## BULLETIN #151

**P-39A**

**IMPROVED SOLENOID IN P-39A ENGINE  
BRAKE FOR CAT C-15/C-16 ENGINES**

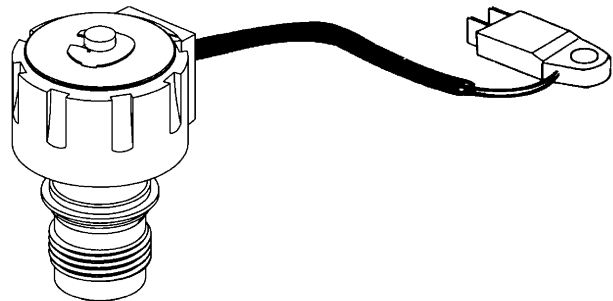
**Pacbrake has released its improved solenoid which eliminates the lead wires and terminal block.**

Caterpillar's undercover wiring will now plug directly onto the external solenoid tabs facilitating easier installation or replacement. The new P39015 solenoid is a direct replacement for P04215 and also eliminates the P02750 button head screw and P02751 lock washer.
